Re: Traffic Peer Review Comments  
Proposed Delivery Station Building  
5 Research Parkway

We are in receipt of VN Engineers' comments dated April 1, 2021, regarding the project noted above. Our responses are indicated below in ***bold italic*** text and are as follows:

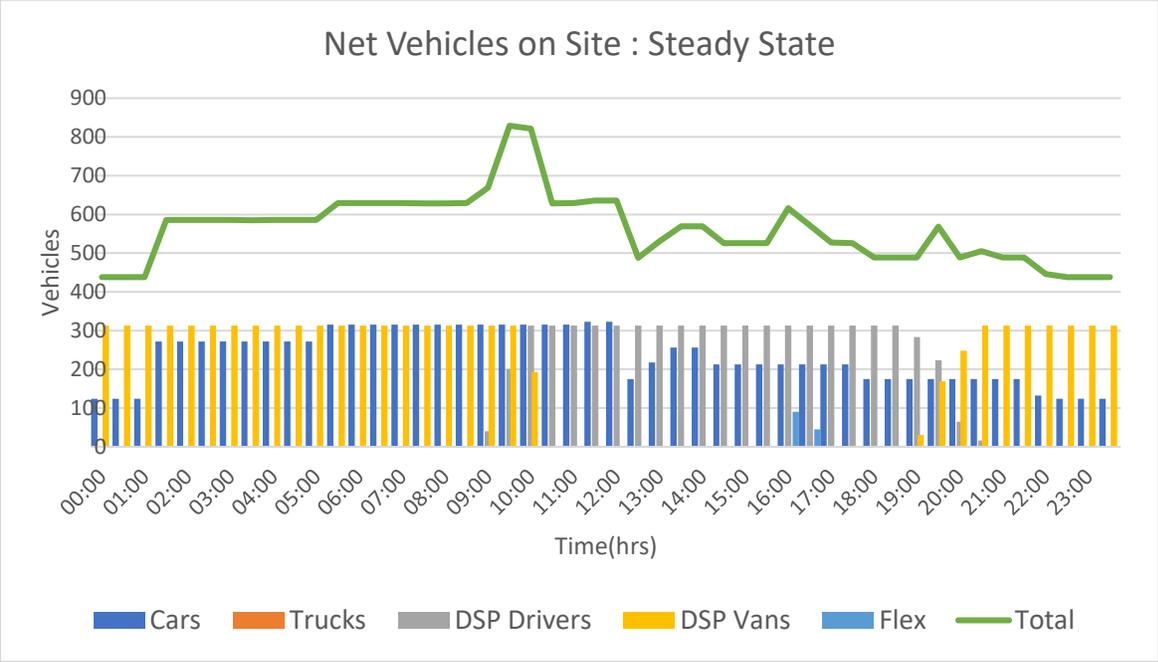
17. The traffic report should provide additional discussion on how the tenant-specific trip generation compares with other similar Land Use Codes (i.e. Warehouse, High Cube Warehouse) in the ITE Trip Generation Manual and why the tenant-specific trip generation is the most appropriate for modeling the traffic impacts of this development.

***Response: Noted, a comparison in trip generation table has been provided in the report.***

## Estimation of Net Vehicles on Site: Holiday Season

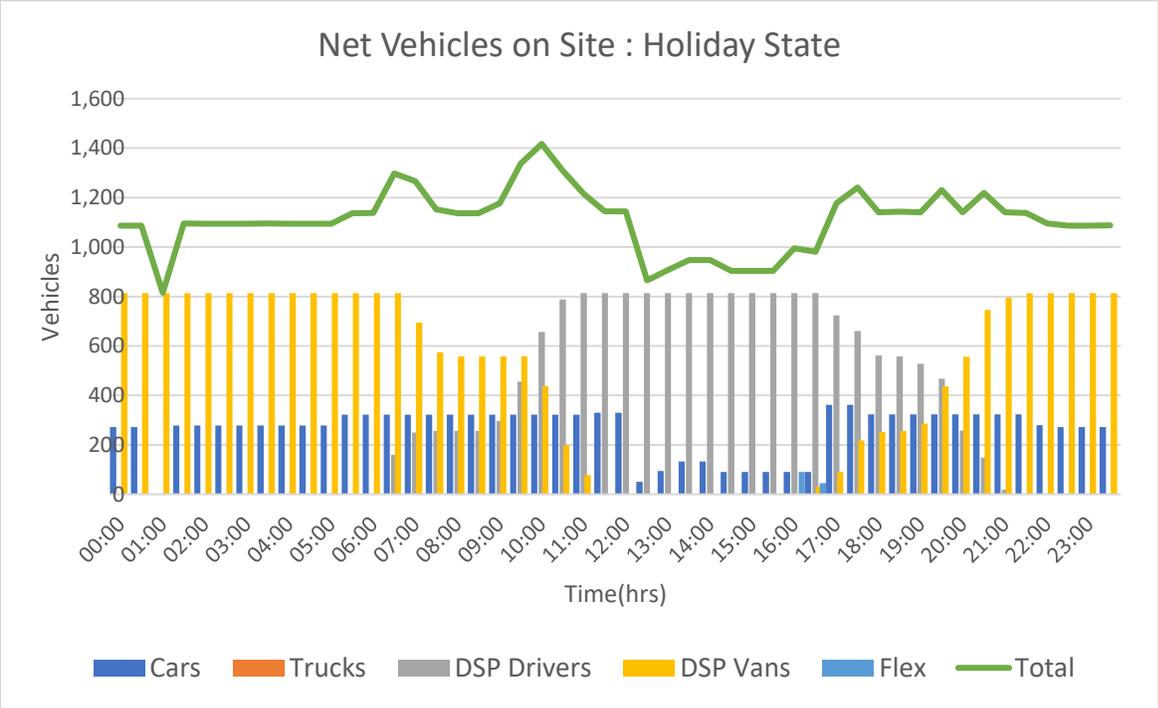
19. The number of parking spaces provided on the site suggest that there will be periods when the trip generation will exceed the 2,196 trips per day. The 1,033 van parking spaces is three times the 344 vans reported to enter and leave the site each day. Assuming an 85 percent parking utilization rate, it is expected that 400 +/- spaces would sufficiently accommodate the daily van load. Assuming an 85 percent parking utilization of the total 1,508 parking spaces proposed on site with a single turnover for each of these spaces per day would correlate to approximately 2,564 trips per day. With higher turnover rates for these parking spaces during shift changes or during periods with higher parking utilization, additional trips can be expected. Additional information should be provided to demonstrate how the parking will be used for the delivery station operations and how much the trip generation would be expected to increase during periods when the parking is fully utilized.

***Response: The additional parking is required for anticipated peak holiday traffic at the Site. 24-hour traffic generation charts have been added to the appendix of the report. Additional analysis for the Holiday Peak is also provided in the Appendix of the report. Charts showing the number of vehicles on Site at any time over a 24-hour period during steady state and Holiday period have been attached to this response to comments.***
